Permit Number: 081152

has permission to Construct 24'x34' boathouse with Grave driveway

AT 67 BROOK LN PEAKS ISLAND

ONE AND TWO FAMILY	PLAN REVIEW	CHECKLIST
Soil type/Presumptive Load Value (Table R401.4.1)		
Component	Submitted Plan	Findings Revisions Date
<b>STRUCTURAL</b>		
① Footing Dimensions/Depth (Table R403.1 & R403.1(1), (Section R403.1 & R403.1.4.1)	not shown	condition
Foundation Drainage, Fabric, Damp proofing (Section R405 & R406)	> N/A	
Ventilation/Access (Section R408.1 & R408.3) Crawls Space ONLY		
② Anchor Bolts/Straps, spacing (Section R403.1.6)	not shown	condition 1/2" diam.
Lally Column Type (Section R407)		
Girder & Header Spans (Table R 502.5(2))		
③ Built-Up Wood Center Girder Dimension/Type	not shown	3-2x10's
Sill/Band Joist Type & Dimensions		
First Floor Joist Species Dimensions and Spacing (Table R502.3.1(1) & Table R502.3.1(2))	slab	
Second Floor Joist Species Dimensions and Spacing (Table R502.3.1(1) & Table R502.3.1(2))	2x8-16" OC - 12' span	-OK
④ Attic or additional Floor Joist Species Dimensions and Spacing (Table R802.4(1) and R802.4(2))	Need 2x8's - 16" OC	OK changed

Boat House - center beam

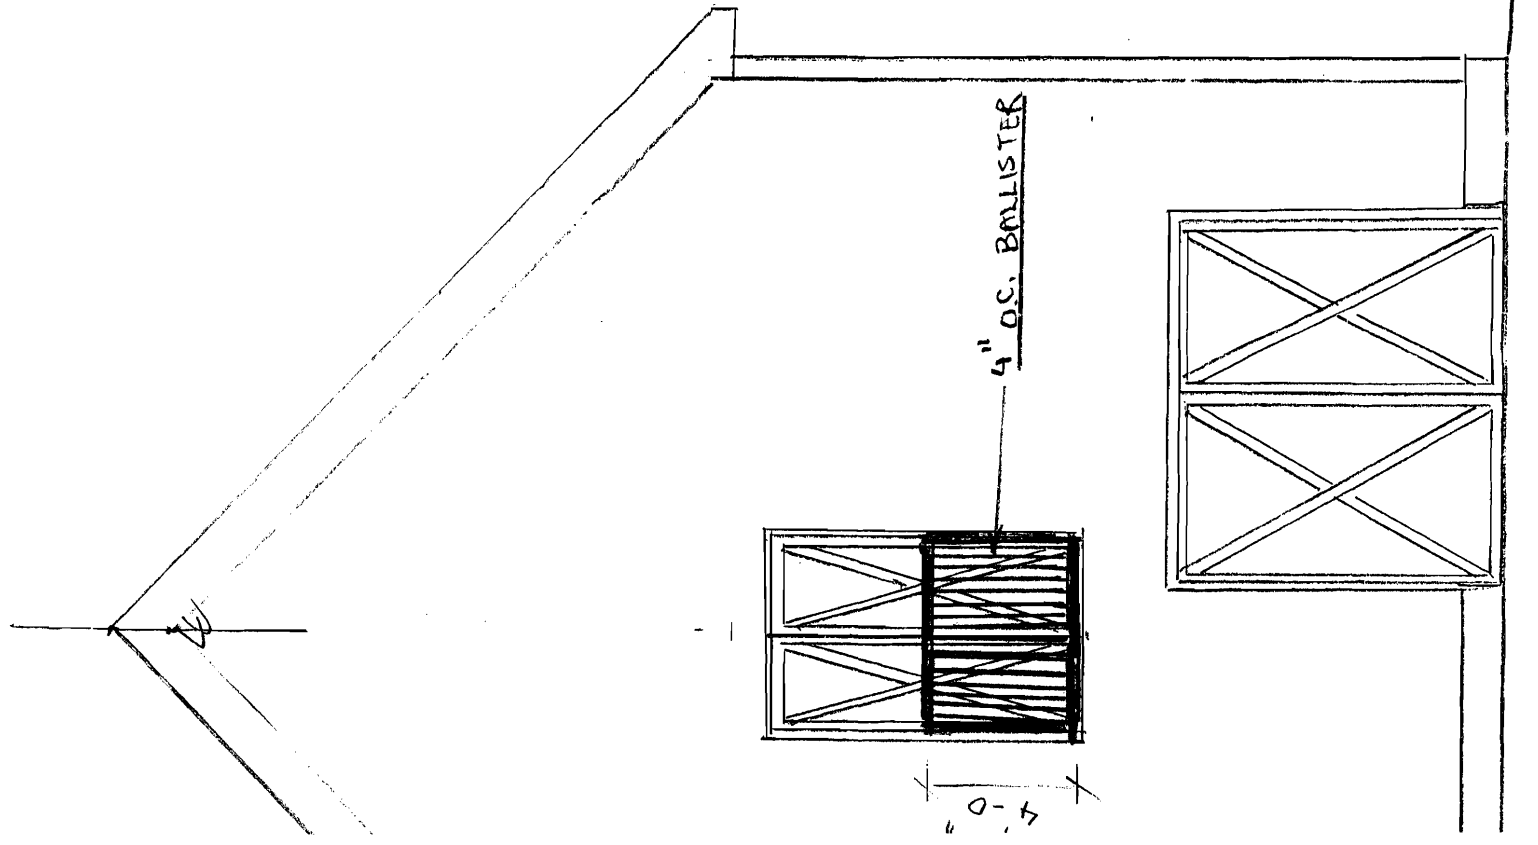
Simple span beam @ 8'-6"  
post spacing

<u>Choice</u>	(3) 2x 12 SPF #2		BASE Fb = 875	ADJ Fb = 875	
<u>Conditions</u>	91 NDS				
	Min Bearing Area	R1= 6.1 in <sup>2</sup> R2= 6.1 in <sup>2</sup>	DL Defl	0.02 in	
<u>Data</u>	Beam Span	8.5 ft	Reaction 1	2602 # Reaction 1 LL 2040 #	
	Beam Wt per ft	12.3 #	Reaction 2	2602 # Reaction 2 LL 2040 #	
	Beam Weight	105 #	Maximum V	2602 #	
	Max Moment	5530 #	Max V (Reduced)	2028 #	
	TL Max Defl	L / 240	TL Actual Defl	L / >1000	
	LL Max Defl	L / 360	LL Actual Defl	L / >1000	
<u>Attributes</u>	Section (in <sup>2</sup> )	Shear (in <sup>2</sup> )	TL Defl (in)	LL Defl	
Actual	94.92	50.63	0.10	0.08	
Critical	75.84	43.46	0.43	0.28	
Status	OK	OK	OK	OK	
Ratio	80%	86%	23%	27%	
<u>Values</u>		Fb (psi)	Fv (psi)	E (psi x mil)	Fc <sub>⊥</sub> (psi)
	Base Values	875	70	1.4	425
	Base Adjusted	875	70	1.4	425
<u>Adjustments</u>	CF Size Factor	1.000			
	Cd Duration	1.00	1.00		
	Cr Repetitive				
	Ch Shear Stress				
	Cm Wet Use

FOOTING DIMENSION
SCALE: 1/4" = 1'-0"
DATE: 1-6-09
DRAWN BY: PL
LOCATION: PEAKS

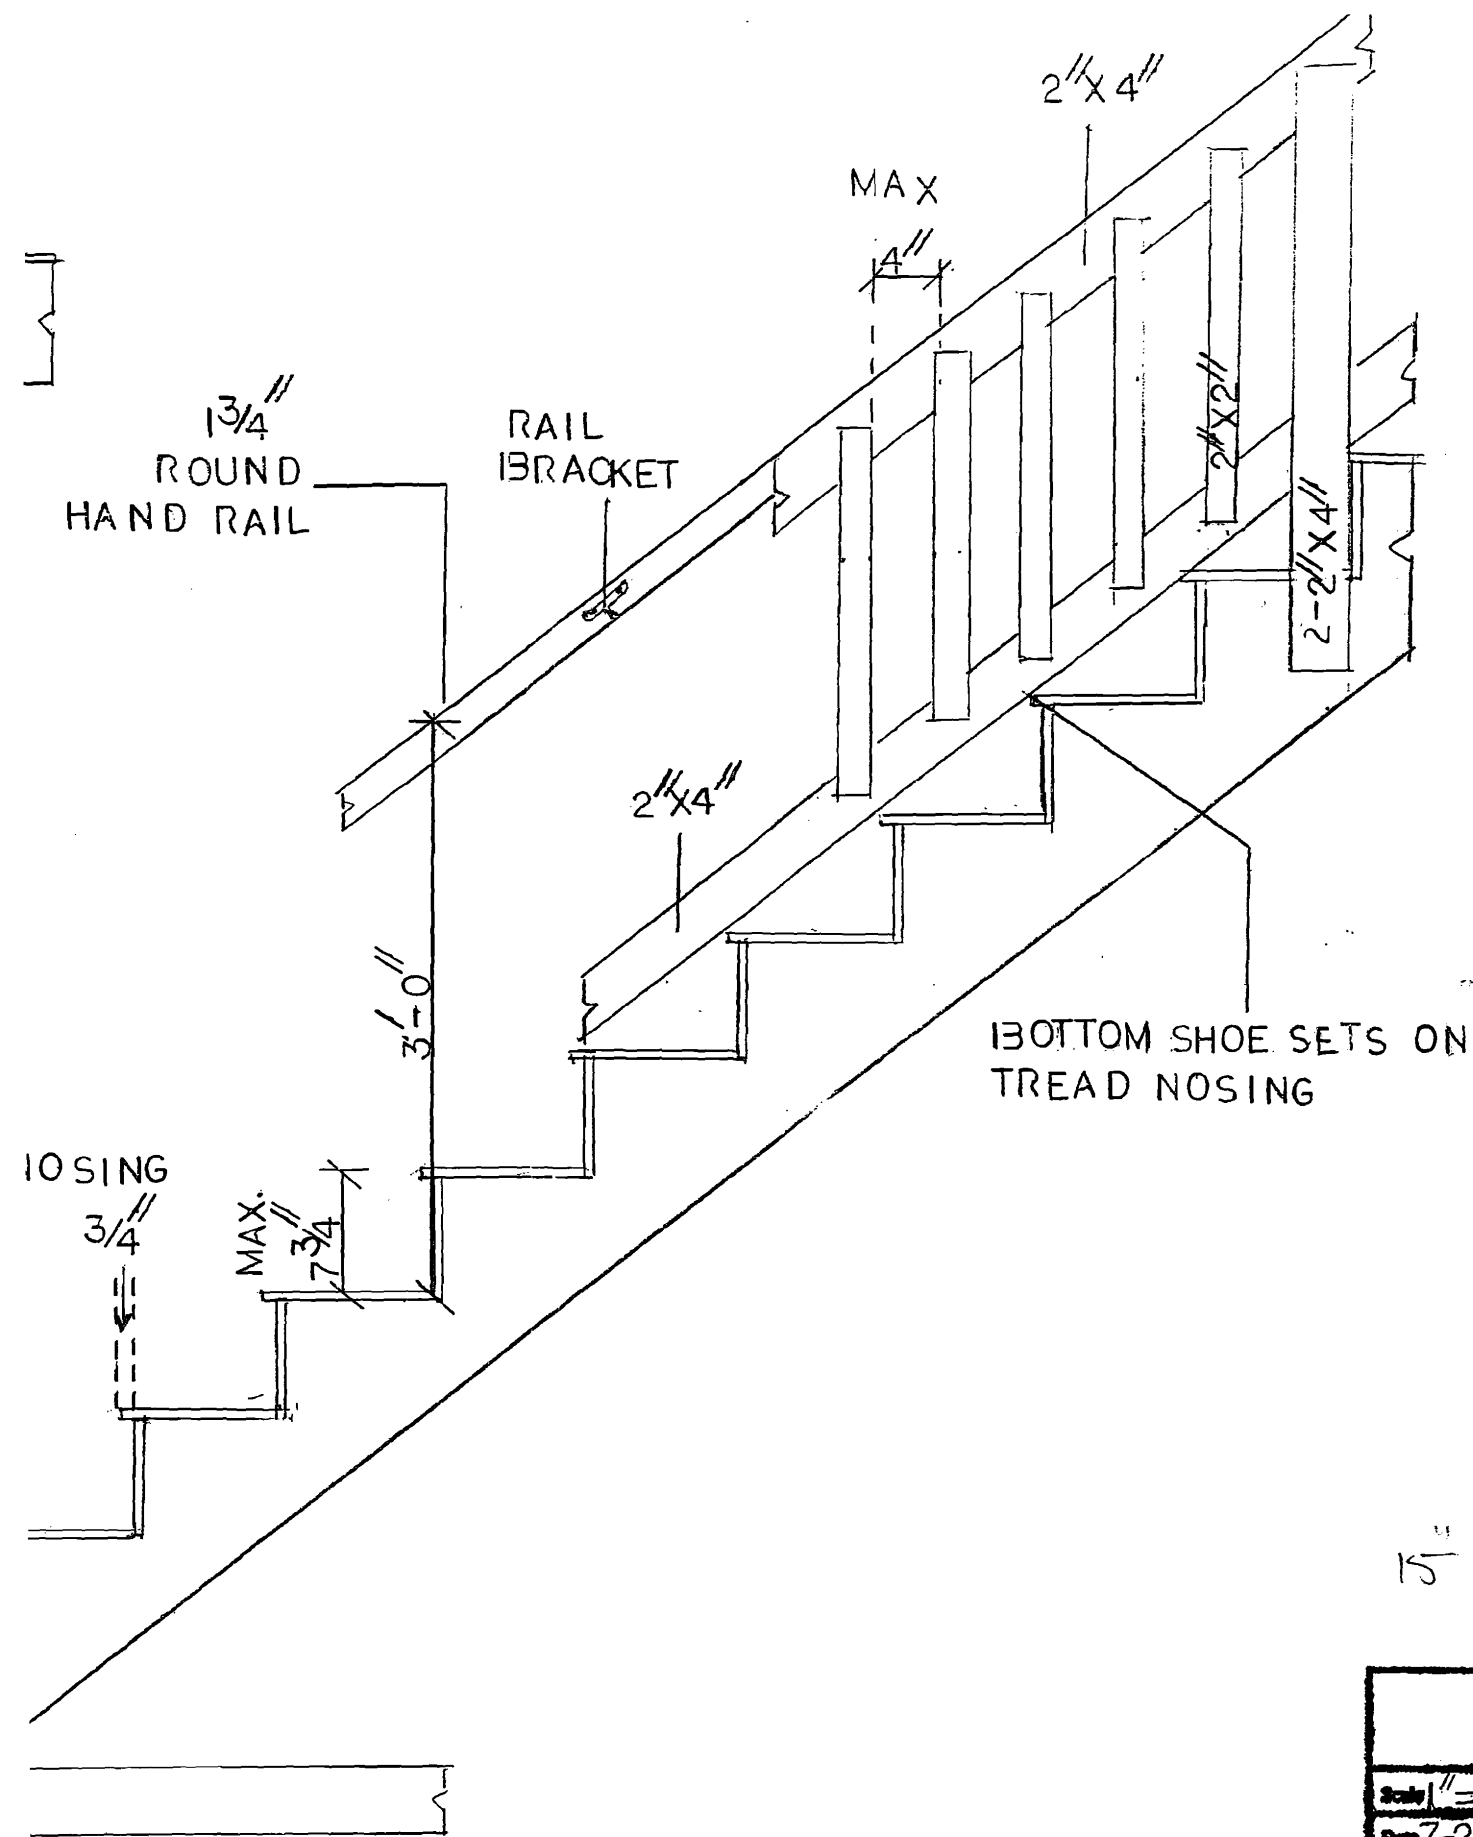
- 1) Permit approved based on the plans submitted and reviewed w/owner/contractor, with additional information as agreed on and as noted on plans.
- 2) As discussed, the frost protection must be installed a minimum 4'-0" below grade with a minimum 8"x 16" footing or the same must be drilled and pinned installed directly on ledge.
- 3) The anchor bolts must be a minimum of 1/2" diameter.
- 4) Separate permits are required for any electrical, plumbing, HVAC or exhaust systems. Separate plans may need to be submitted for approval as a part of this process.
